**GE Hitachi Nuclear Energy**

MFN 08-232  
Supplement 2

**Subject: Revised Response to Portion of NRC Request for Additional Information Letter No. 198 Related to ESBWR Design Certification Application – DCD Tier 2 Section 3.7 – Seismic Design – RAI Number 3.7-63 S01**

**RAI Number 3.7-63 S01 (Revision 1)**

**Figure 3.7-63(1) Comparison of Surface Response Spectra for Layered Case 2 when the Input Motion is applied at Different Levels**

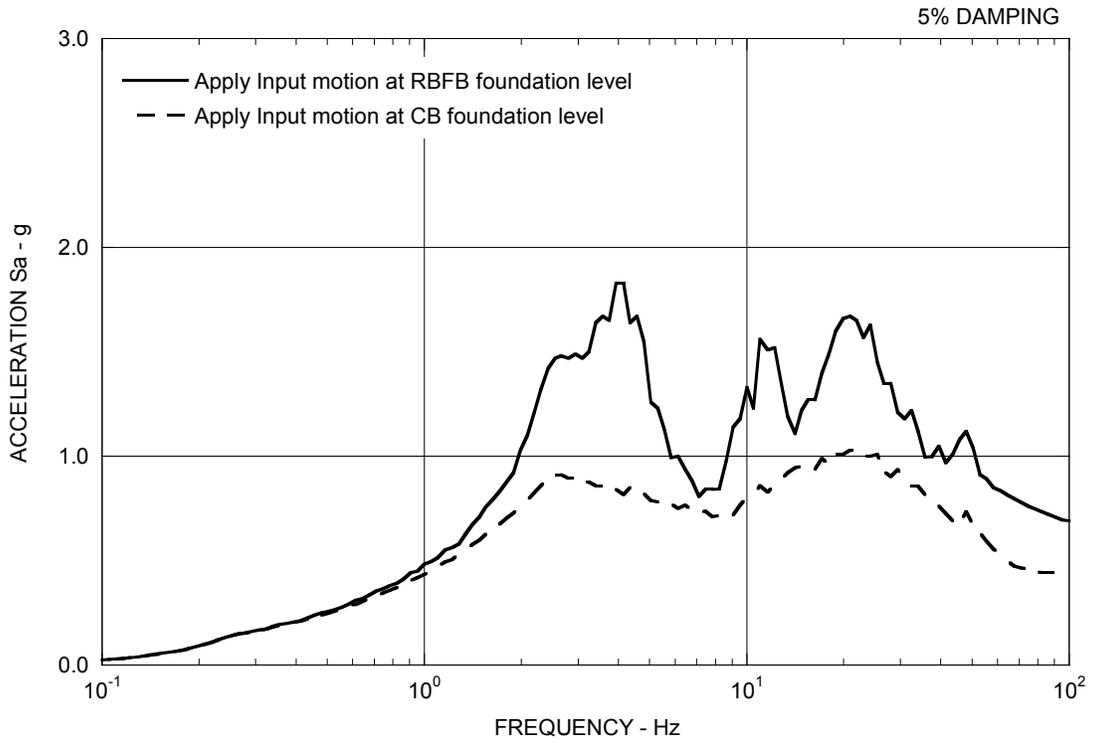
- (a) Based on the first two sentences above, it appears to the staff that the ground motion for the CB was applied at two different elevations: at the CB foundation level for the generic sites defined in Subsection 3A.3.1, and at the RFBF foundation level for the layered site cases. Please confirm this, or clarify what was actually done. If this is the case, please describe what differences in CB response would be expected for the layered site cases if the input ground motion had been defined as an outcrop motion at the CB foundation level.*

*In reviewing Figure 3.7-63(1), the staff noted that the surface spectra corresponding to placing the input motion at the bottom of the CB foundation (dashed line) does not appear to be correct. It resembles the spectrum of the input motion, at the foundation level. The dashed line would be expected to exhibit the same pattern of peaks and valleys as the solid line. GEH needs to confirm that the dashed line is correct, and provide an explanation for the unexpected shape.*

foundation level. This is demonstrated in Figure 3.7-63(1) by comparing the response spectra of the surface motion when the ground motion is applied at the RBFB foundation level and at the CB foundation level for the typical layered site Case 2 described in DCD Tier 2 Table 3A.3-3. The response spectrum of the surface motion is larger in the case when the ground motion is applied at the RBFB foundation level than in the case when the ground motion is applied at the CB foundation level. Therefore, it is expected that the CB response would be smaller for the layered site cases if the input ground motion had been defined as an outcrop motion at the CB foundation level instead at the RBFB foundation level.

GEH confirms that both the solid and dashed lines in Figure 3.7-63(1) have been correctly calculated by using the method identified as the DCD Method in GEH's response to NRC RAI 3.7-16, Supplement 2 transmitted to the NRC via MFN 06-274, Supplement 2, which includes the entire soil column up to the ground surface in a single SHAKE run with outcrop motion input at the foundation level.

The reason for the dashed line resembling the foundation input spectrum is because the CB (14.9 m embedment) is shallower than the top layer (20m thick) of the layered sites (see DCD Tier 2 Table 3A.3-3). In other words, the soil properties above the foundation are the same as those below the foundation in the region of the top layer and, as a result, the surface motion resembles the foundation input motion. This can be further explained by the one-dimensional wave propagation theory below:

**Figure 3.7-63(2) Comparison of Horizontal SSE Design Response Spectrum with NA3 Site-Specific Spectra at FWSC Foundation Level (Reproduced from North Anna 3 COLA FSAR Figure 2.0-203)**

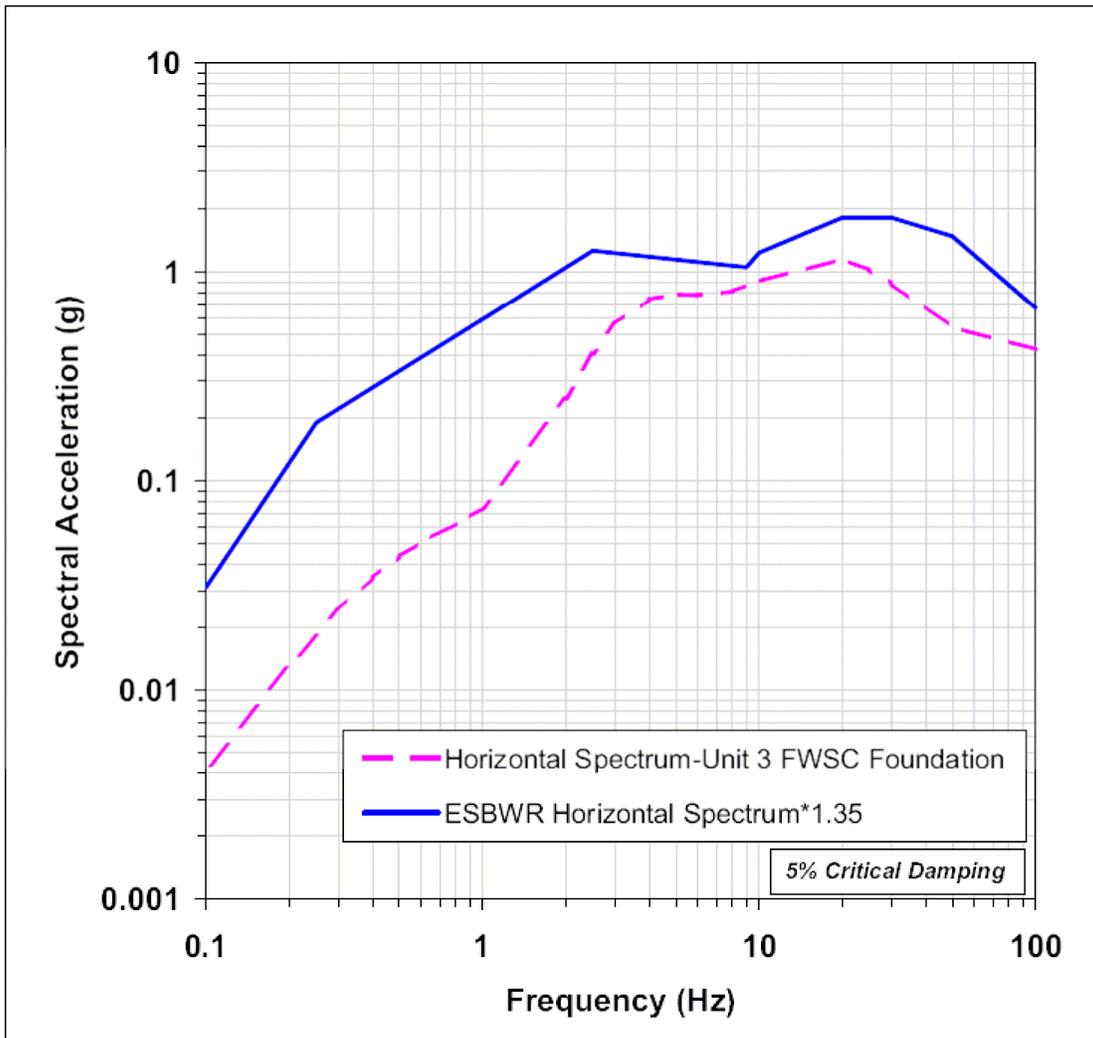
- (b) The third sentence above defines the input ground motion used for the FWSC SSI analyses as “1.35 times the RFBF/CB foundation input motion...applied directly at the foundation level.” Please provide a detailed technical basis for the selection of the 1.35 factor, including pertinent quantitative information upon which this determination is based.*

*The staff believes that the surface spectra used for seismic analysis of the FWSC should envelope the 8 surface spectral plots that the staff has asked GEH to derive under Part (1) above. This would ensure consistency between the input at the RB/FB and CB foundation levels and the input at the surface for the FWSC. GEH's proposed 1.35 factor on the input motion at the bottom of the RB/FB foundation may or may not produce a suitable envelope. Based on comparing Figure 3.7-63(1) to Figure 3.7-63(2), it appears to the staff that a 1.35 factor may not be sufficient over the entire frequency range.*

- (b) The technical basis for scaling the RBFB/CB foundation input motion for ground motions at other depths is to maintain a broad-band spectrum shape that is rich in all frequencies, regardless of site conditions, for the purpose of standard plant design. Broad-band design spectrum at any foundation depth is compatible with smooth site-specific ground motion response spectrum (GMRS) and associated foundation input response spectrum (FIRS) generated in accordance with RG 1.208 requirements for new units. The 1.35 scale factor was determined such that the resulting spectrum at the FWSC foundation level envelops the FIRS at the North Anna 3 site as shown in Figure 3.7-63(2) for the horizontal motion and Figure 3.7-63(3) for the vertical motion.

**Figure 3.7-63(4) Comparison of Surface Response Spectra for Layered Case 1**

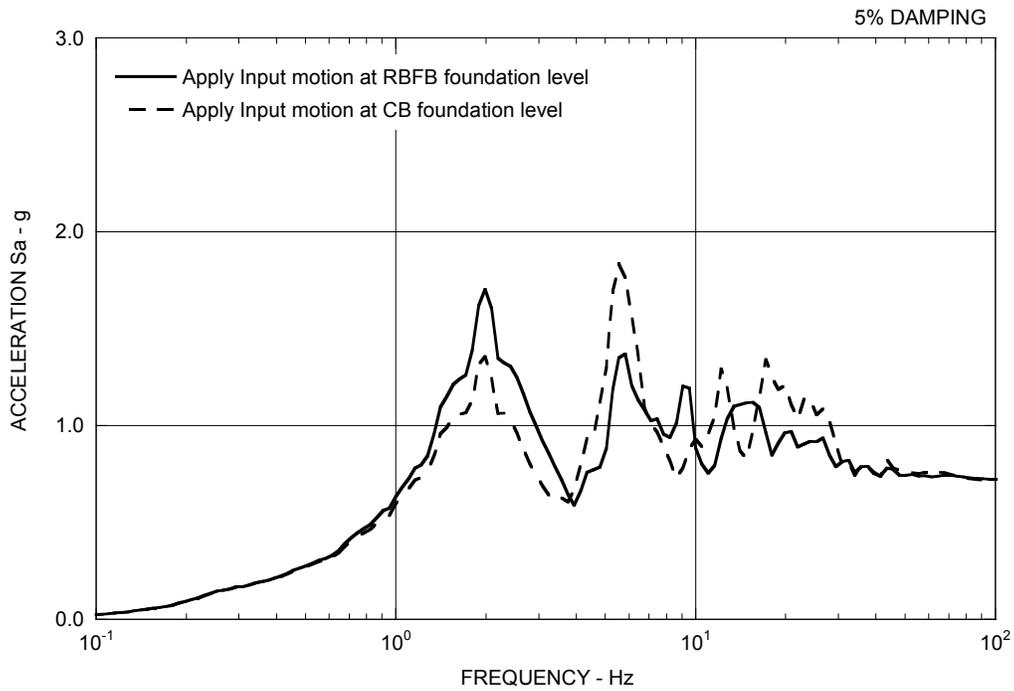
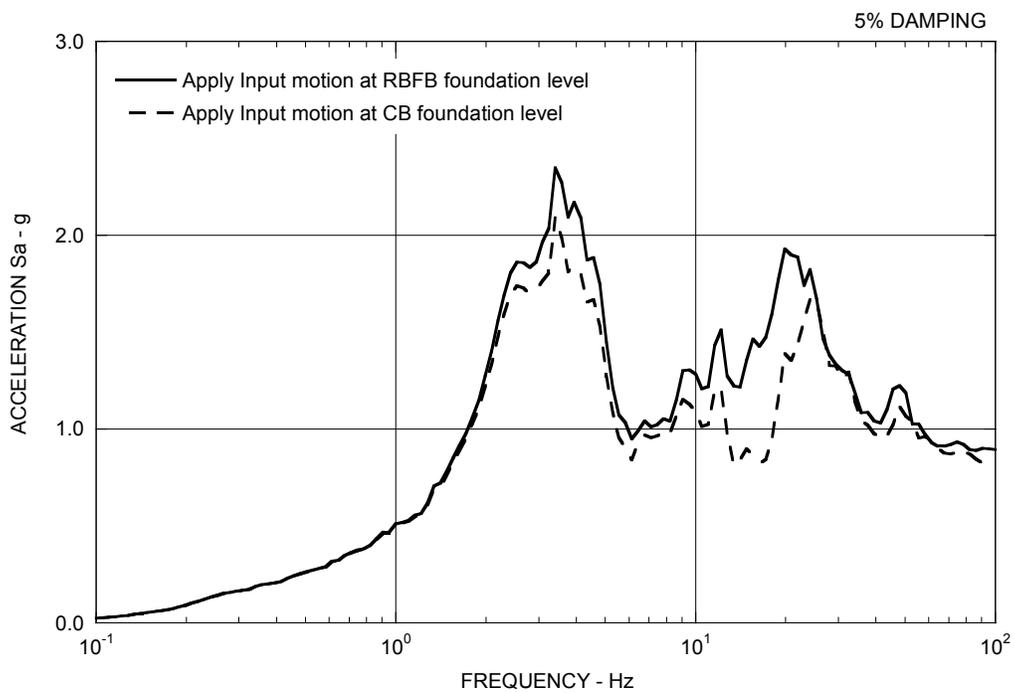
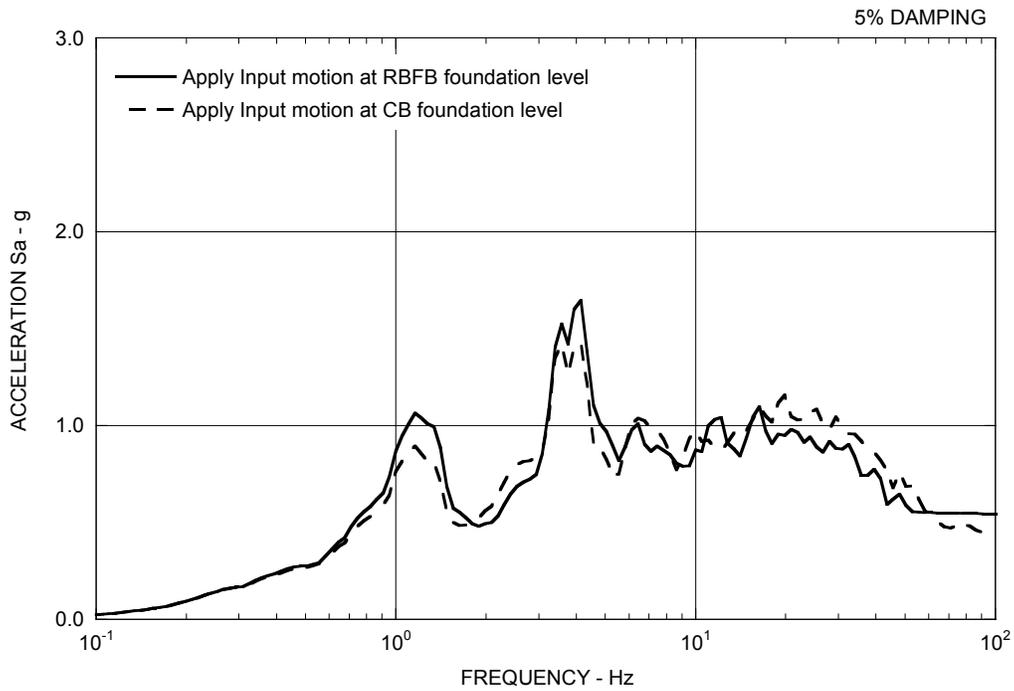
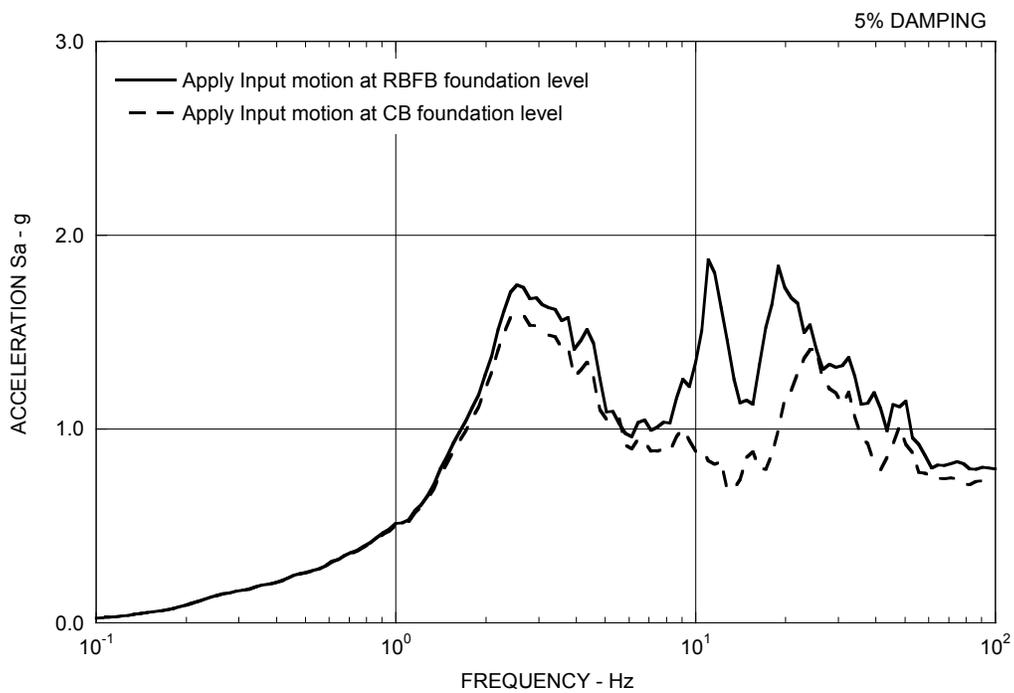
*Part (1) - GEH needs to submit a comparison of the surface spectra derived by placing the input motion at the bottom of the RB/FB foundation to the surface spectra derived by placing the input motion at the bottom of the CB foundation, for each of the 4 SASSI layered soil cases. In deriving the surface spectra from the foundation motions, the method identified as the NRC method in GEH's response to RAI 3.7-16 must be used. Submit four (4) figures, similar to Figure 3.7-63(1).*

*Part (1) - Figures 3.7-63(4) through (7) show comparisons of the surface spectra derived by placing the input motion at the bottom of the RB/FB foundation to the surface*

spectra derived by placing the input motion at the bottom of the CB foundation for each of the 4 SASSI layered soil cases by using the method identified as the NRC Method in GEH's response to NRC RAI 3.7-16, Supplement 2 transmitted to the NRC via MFN 06-274, Supplement 2.

Part (2) - The surface spectra computed from the input spectra defined at the RB/FB and CB foundations, as shown in Figures 3.7-63(4) through 3.7-63(7), exhibit distinct peaks and valleys. Using these surface spectra directly as input motion could under-predict or over-predict the FWSC response depending on the SSI frequencies. The more balanced approach for the standard plant design is to maintain the broad-band characteristics in the foundation input spectra that is rich in all frequencies, regardless of site conditions. This is the technical basis for the selection of FWSC input spectra to be 1.35 times the broad-band Certified Seismic Design Response Spectra (CSDRS) for the RB/FB and CB. As stated in the original response to this RAI, the 1.35 scale factor was chosen to envelop the FWSC Foundation Input Response Spectra (FIRS) at the North Anna 3 site. To ensure the seismic adequacy of the FWSC at each site, the COL applicant is required to compare the site-specific FIRS for the FWSC with the FWSC CSDRS, which is 1.35 times the values shown in DCD Tier 2 Figures 2.0-1 and 2.0-2 as stipulated in footnote 9 to DCD Tier 2 Table 2.0-1.
